Proposal #07: 1060-27-74, WISC 2025597
I-94 East West, Early East Leg
30th Street to 25th Street
IH 94
Milwaukee County

This is Addendum No. 01, which provides for the following:

ADDENDUM NO. 01

Addendum No. 01
ID 1060-27-74
Revised Sheet 77
August 12, 2025

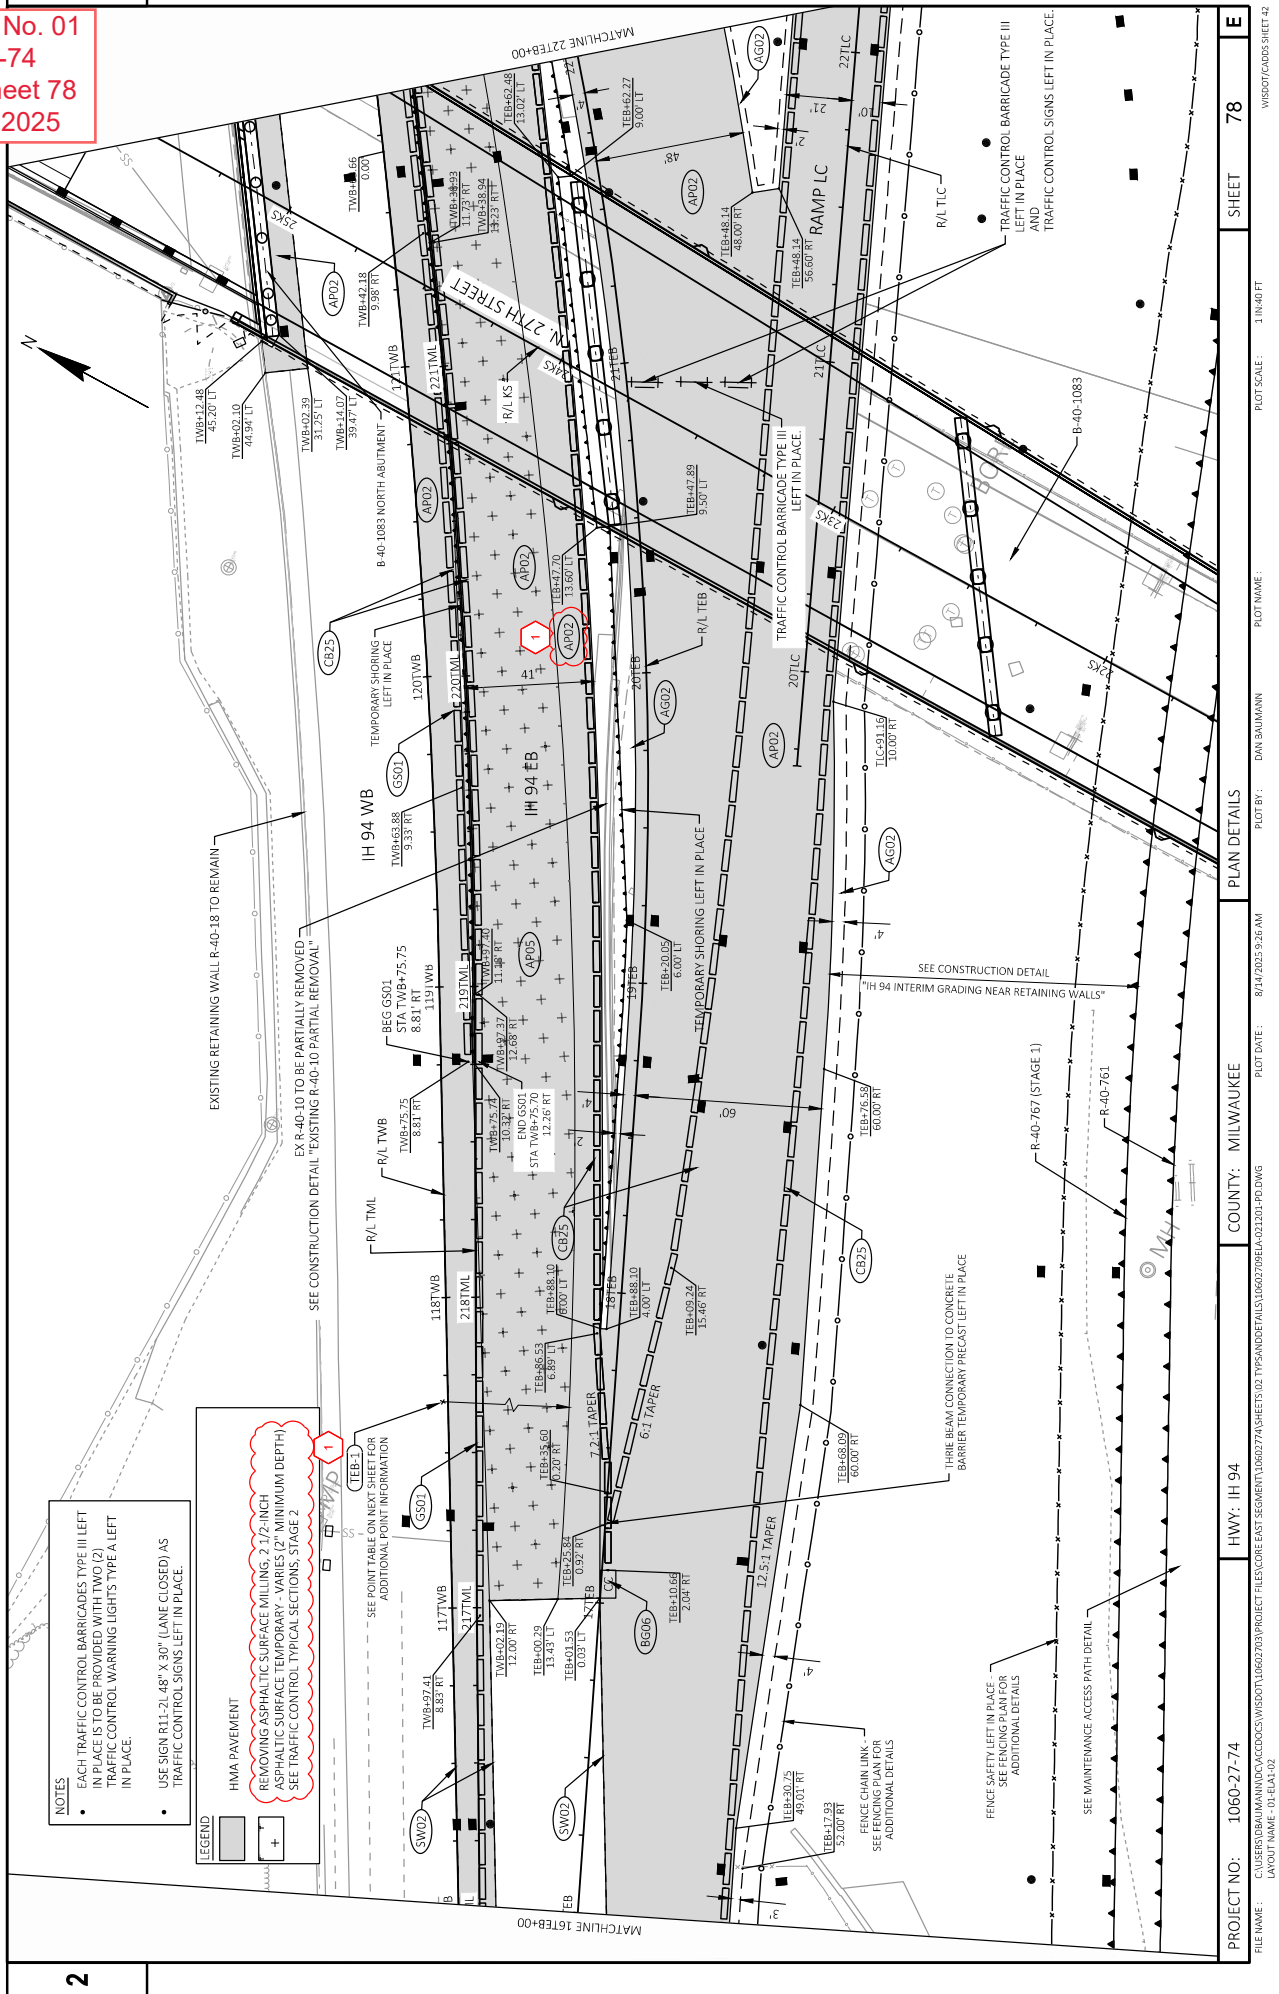
Revised Plan Sheets	
Plan Sheet	Plan Sheet Title (brief description of changes to sheet)
76	Plan Detail (Legend) – Updated asphalt type
77-79	Plan Detail – Updated asphalt type and note in legend
81	Plan Detail – Updated asphalt type and note in legend
373	Miscellaneous Quantities – Base Aggregate Dense Table
